Reference	SSM72569
Models	Discovery Sport / L550 Range Rover Evoque / L538
Title	L550 & L538 16MY 9HP48 9-Speed - An incorrect bolt fitment on GTDI transmission to engine
Category	Driveline
Last modified	22-Dec-2015 00:00:00
Symptom	504000 Other Automatic Transmission Concerns
Attachments	Trans Bolt FS110306 Location.pdf (Trans Bolt FS110306 Location.pdf)

Trans Bolt FS110306 Location

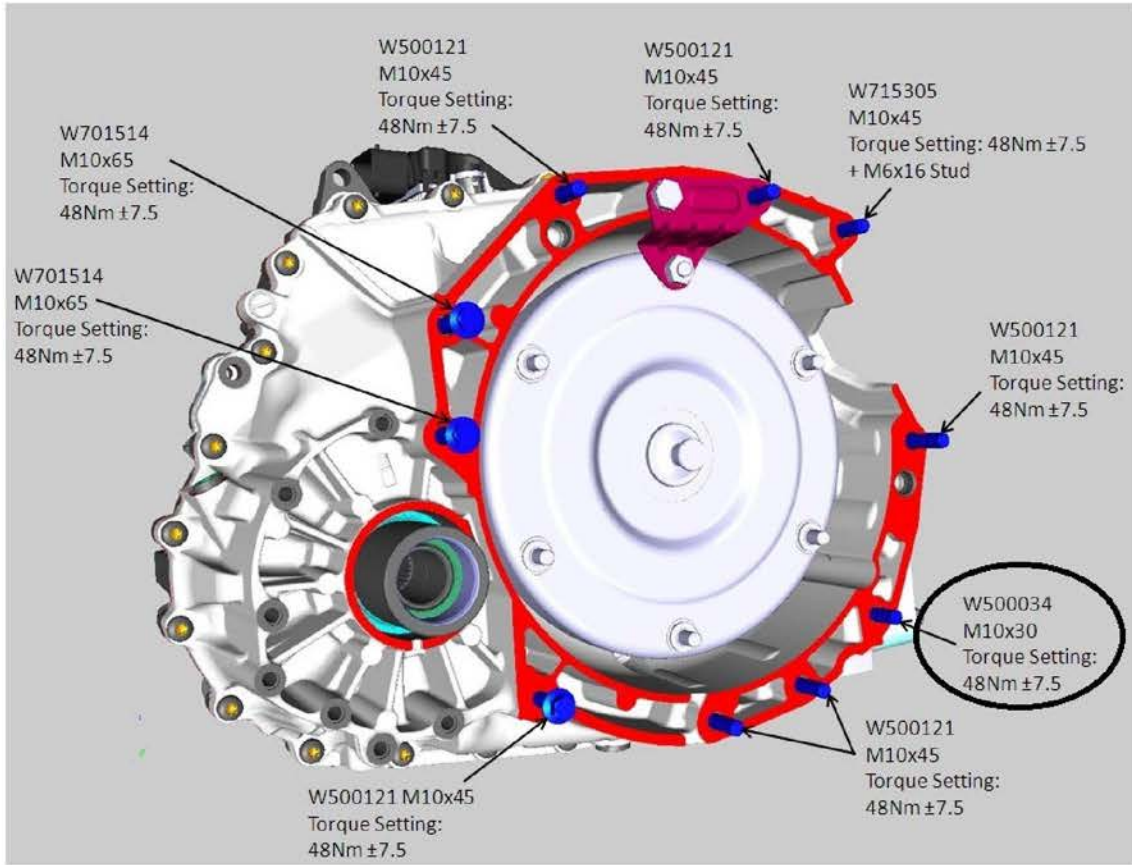
Transmission supporting bolt incorrectly fitted at the manufacturing plant and under normal operation there is no effect.

When reusing the transmission bolt identified in the attachment, it is possible to strip the sump thread when reinstalling the bolt.

Replacement required when refitting the transmission on the affected VIN ranges below.

Incorrect transmission bolt fitted at manufacturing plant.

Any dealers carrying out any service work when replacing 9HP48 9-Speed Automatic Transmission, or engine replacement or any other service repairs in this area on the above VIN range please discard the transmission bolt as identified in the attachment.

This bolt should be replaced with part number FS110306 and torqued to 48Nm \pm 7.5
